CITY PLAN COMMISSION STAFF REPORT

KC Outlook

Docket #7 Request

Report Date: August 13, 2021
Case Number: CD-CPC-2019-00055
Project: 45th & Troost Mixed Use

1 DEVELOPMENT SITE PLAN
SCALE: 1"=30'-0"

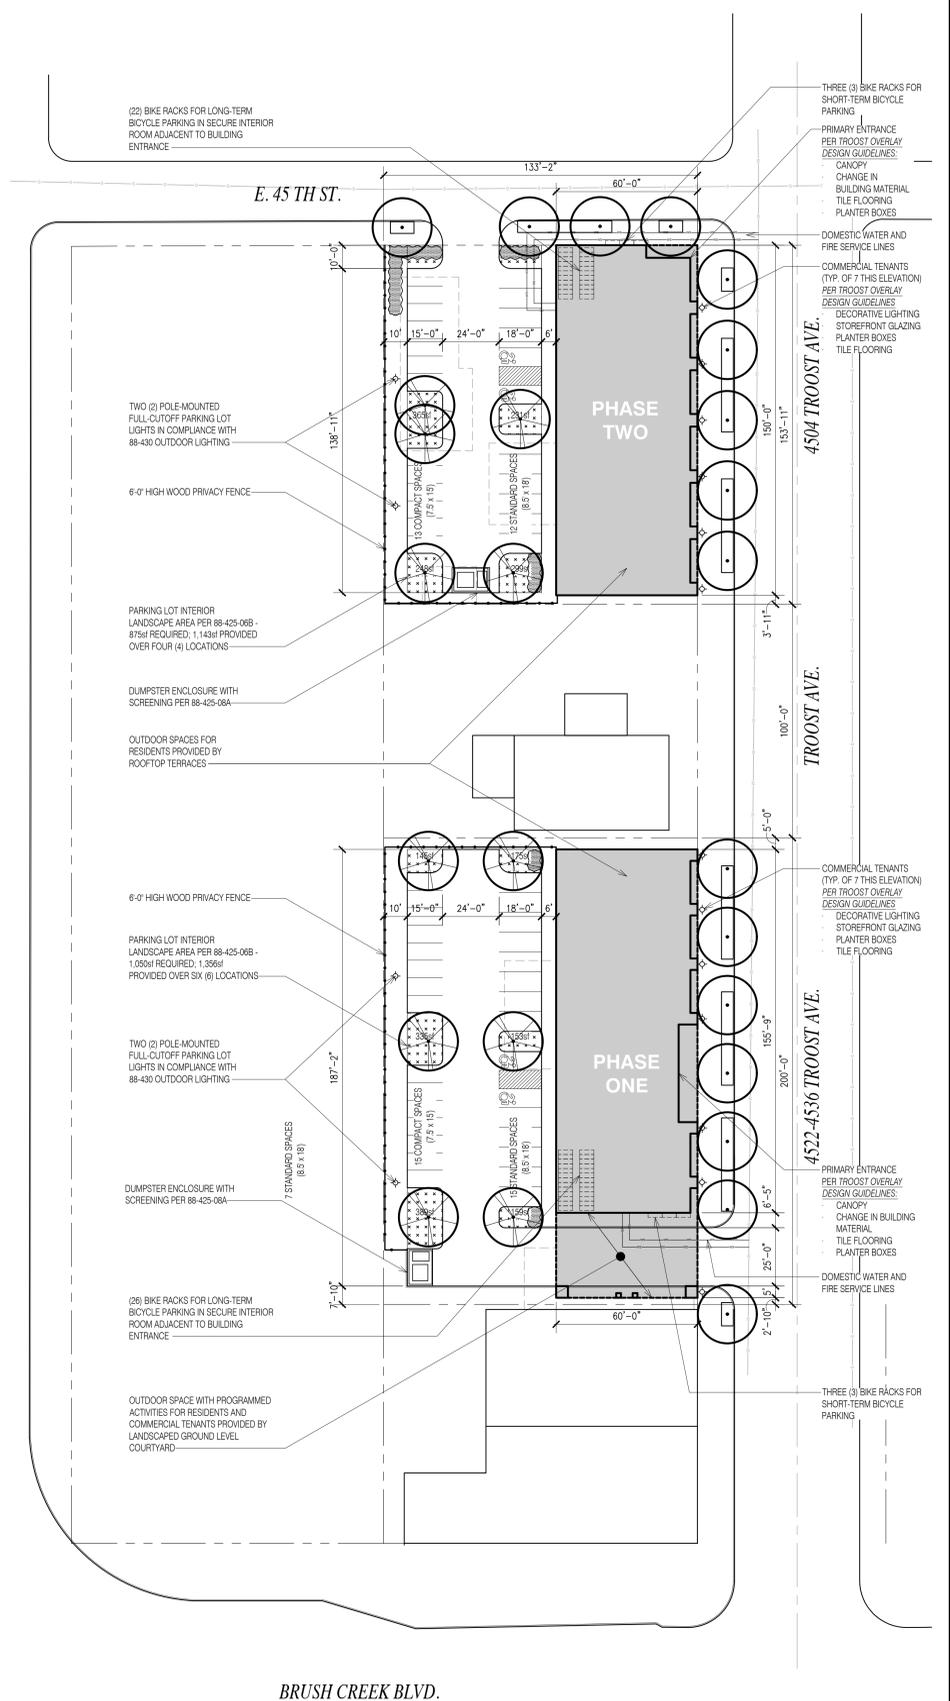
1. Provide an outdoor lighting plan conforming to 88-430. Revise Plans and Resubmit (4/14/2020)
2. Per the Troost Overlay, maximum building frontages on Troost is 150'; the southern building exceeds this maximum. A variance, reviewed by the Board of Zoning Adjustments, would be required to exceed this maximum. Separate variance application must be filed on CompassKC. Revise Plans and Resubmit (5/20/2020)
3. Provide detail on pedestrian crossing safety measures for crossing of parking entrance.

Include crosswalk demarkation including raised/stamped/colored concrete, use of other material, or the like to provide clear safe passage across. Revise Plans and Resubmit (5/20/2020)

4. Collate and bind all plan set into one and resubmit. Revise Plans and Resubmit (3/11/2021)
5. Show parking required and parking provided per 88-420 on the face of the plan. If waivers or deviation is been requested, it must be requested. Revise Plans and Resubmit (3/11/2021)

7. Show all chronological plan revision dates on the face of each plan sheet or the plan cover sheet. Revise Plans and Resubmit (8/13/2021)
8. Call out any request for waiver or deviation on the face of the plan. The south building still exceeds the 150' maximum building width. Revise Plans and Resubmit (8/13/2021)

9. Update the parking calculation to show the narrative provided with the revised plan on the face of the plan. Revise Plans and Resubmit (8/13/2021)
10. Clearly depict all POS tracts and amenities to be dedicated in lieu of parkland. Revise Plans and Resubmit (8/13/2021)
